Subject: Transmission Main Case – Oil Cooler Port Thread Change

Document Number: TAIB0864

Date: June 12, 2017

Subject: Misprinted Advantage Series Clutch Box Labels

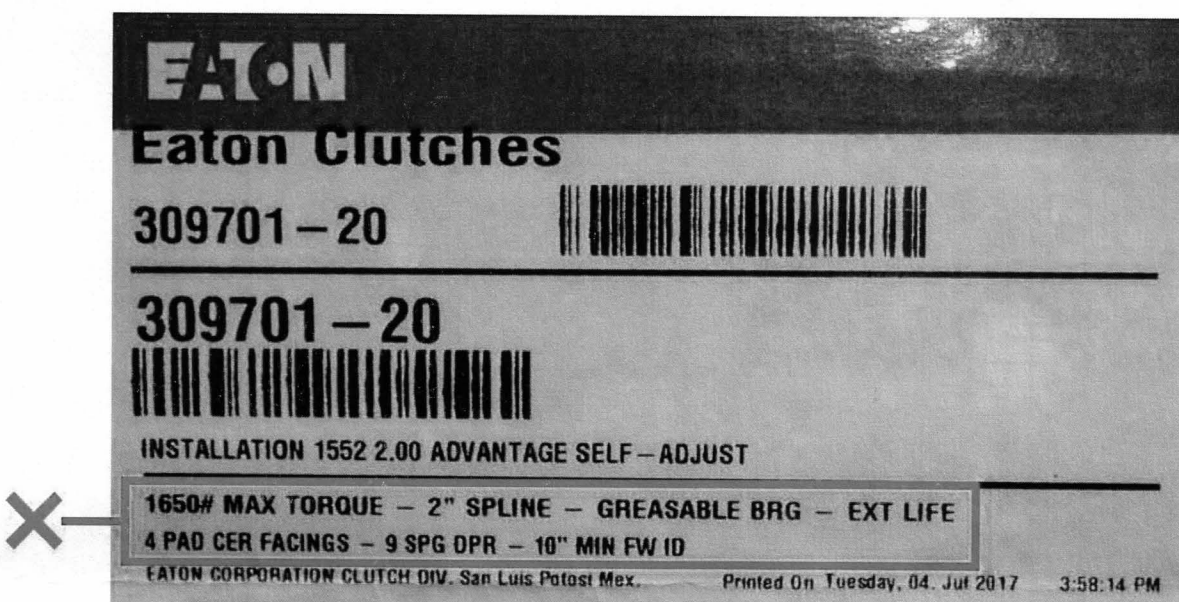
Some Advantage Series clutches manufactured between June 24 – July 21, 2017 may have box labels misprinted with incorrect product information including:

- Torque Ratings
- Number of Facings
- Number of Dampener Springs

This misprinting does not affect product performance. Box labels are printed with correct part numbers and clutches are properly manufactured, but labels may be printed with an inaccurate description of the clutch within. Use the [Eaton Clutch Selector \(CLSL1511\)](#) for correct product descriptions.

Eaton will send corrected replacement labels to customers requesting them.

Fix as identified. Corrected replacement labels will be sent to customers requesting them. Send requests to: GalesburgAftermarketCS@eaton.com
